MECKLENBURG COUNTY
HEALTH DEPARTMENT

APPLICATION FOR A RESIDENTIAL SITE IMPROVEMENT PERMIT/ CONSTRUCTION AUTHORIZATION FOR AN ON-SITE WASTEWATER SYSTEM, NEW WELL INSTALLATION, OR REPAIR OF EXISTING WELL

IMPROVEMENT PERMIT/CONSTRUCTION AUTHORIZATION
for an ON-SITE WASTEWATER TREATMENT & DISPOSAL SYSTEM

File #: 9702B Permit #: 8856 Tax Parcel #: 113-163-26

SKETCH OF SYSTEM LAYOUT
(Proposed Layout)

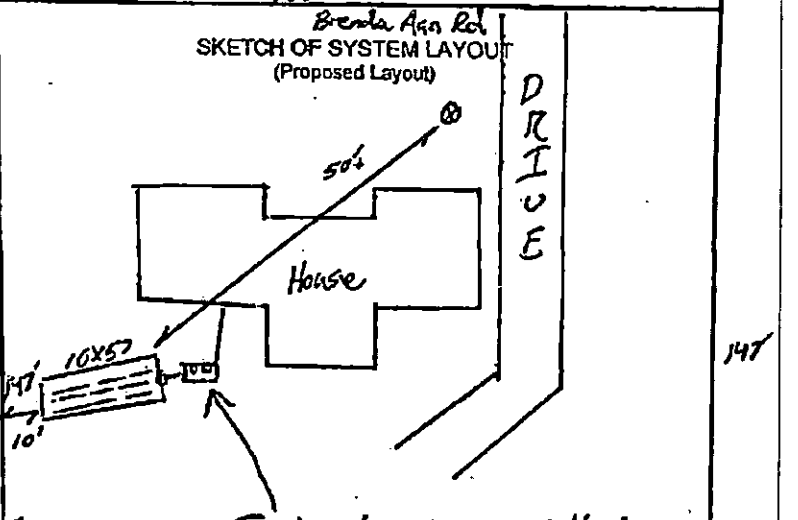
Improvement Permit/Construction Authorization: 130A-336(a) - Facility/appurtenance setbacks shown from fixed points?	N/A
Corrections/modifications needed?	Yes
Comments:	
IA issued date:	
OP Issued date:	6-2-17
Review performed by:	Jeremy Michael
Date performed:	6/14/2017

Owner needs to sign the permit

IP should not be dated JUST CA
